NINE MILE POINT NUCLEAR STATION, UNIT NO. 1

AMENDMENT TO FACILITY OPERATING LICENSE

Amendment No. 26
License No. DPR-63

ATTACHMENT TO LICENSE AMENDMENT NO. 26

Figure 3.3.2 a
ALLOWABLE PRESSURE SUPPRESSION SYSTEM
4 FOOT DOWNCOMER SUBMERGENCE

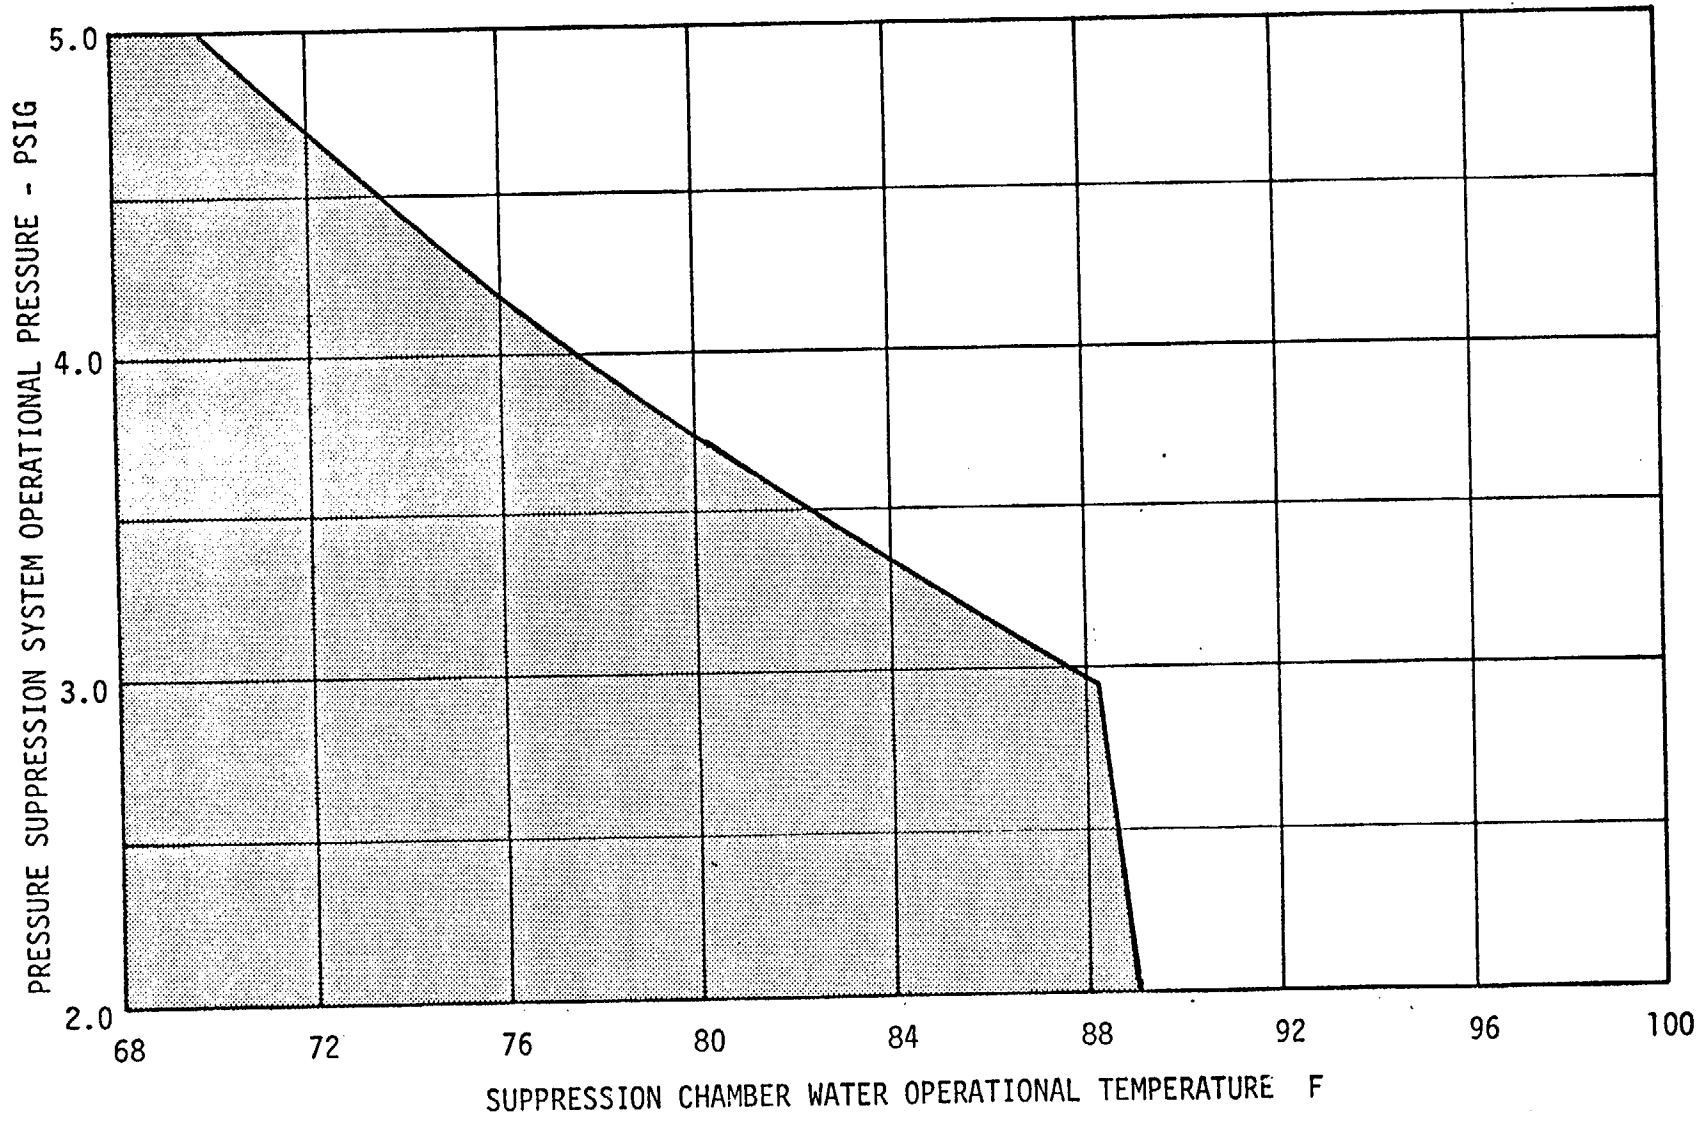
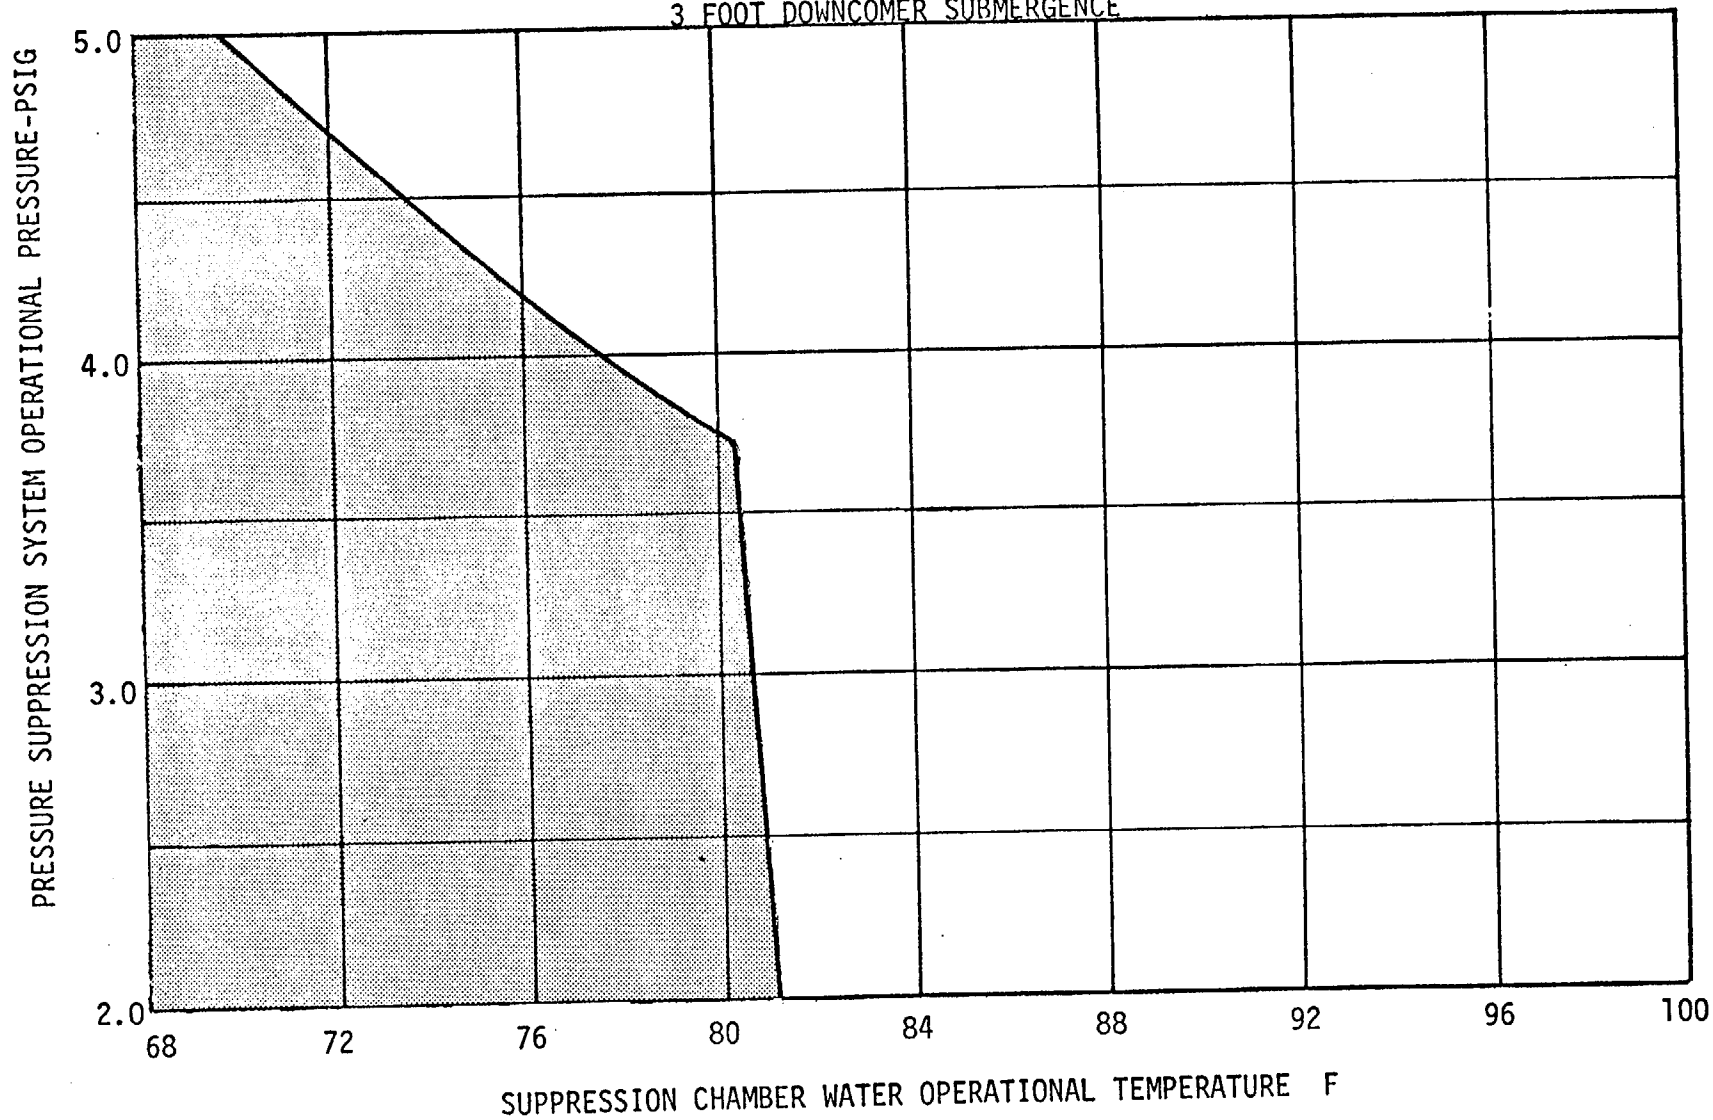
- (1) Figure 3.3.2a when downcomer submergence is ≥ 4 feet, or (2) Figure 3.3.2b when downcomer submergence is ≥ 3 feet. If these temperatures are exceeded, pool cooling shall be initiated immediately.

FIGURE 3.3.8

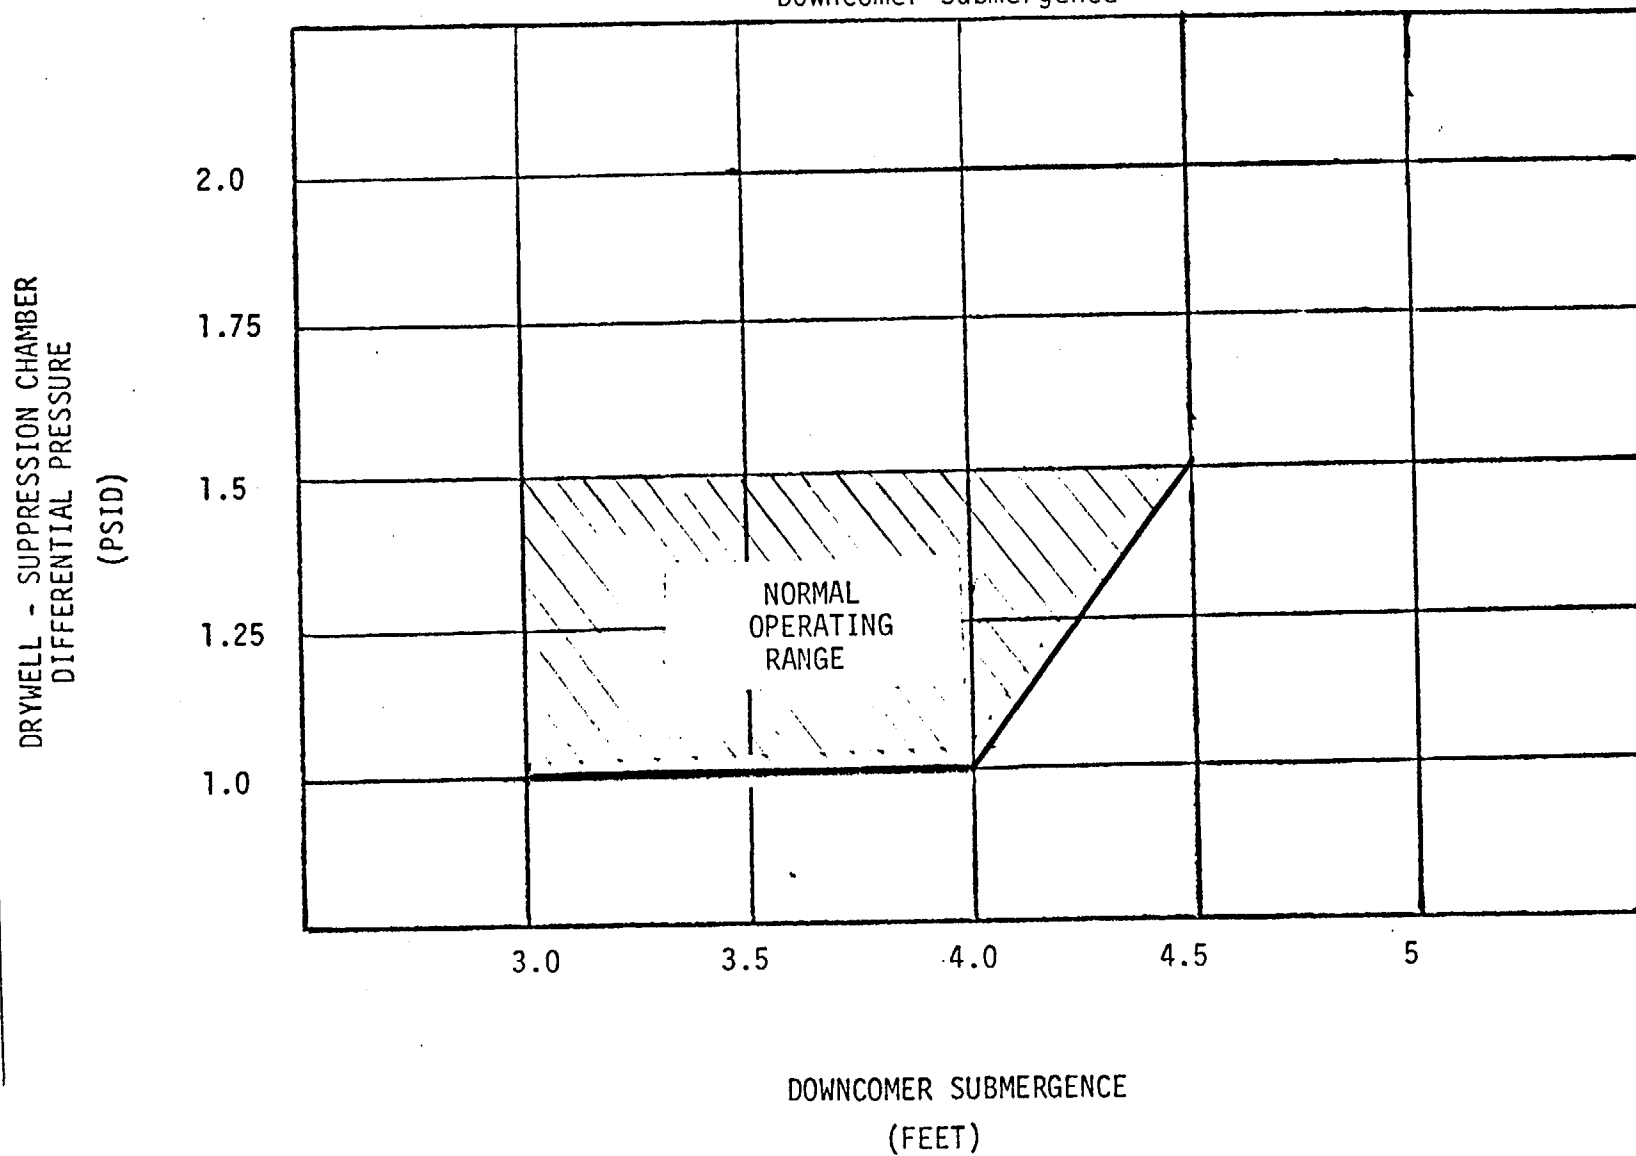
- a. Differential pressure between the drywell and suppression chamber shall be maintained at or above levels according to Figure 3.3.8 except as specified in (1) and (2) below:
 - (1) The differential pressure shall be established within 24 hours of achieving operating pressure and temperature. The differential pressure may be reduced to less than that specified by Figure 3.3.8 24 hours prior to a scheduled shutdown.
 - (2) This differential may be decreased to less than that of Figure 3.3.8 for a maximum of four (4) hours during required operability testing of the drywell-suppression chamber vacuum breakers.

- b. If the differential pressure of Specification 3.3.8.a cannot be maintained and the differential pressure cannot be restored within the subsequent six (6) hour period, an orderly shutdown shall be initiated and the reactor shall be in a Hot Shutdown condition in six (6) hours and a Cold Shutdown condition within the following 18 hours.
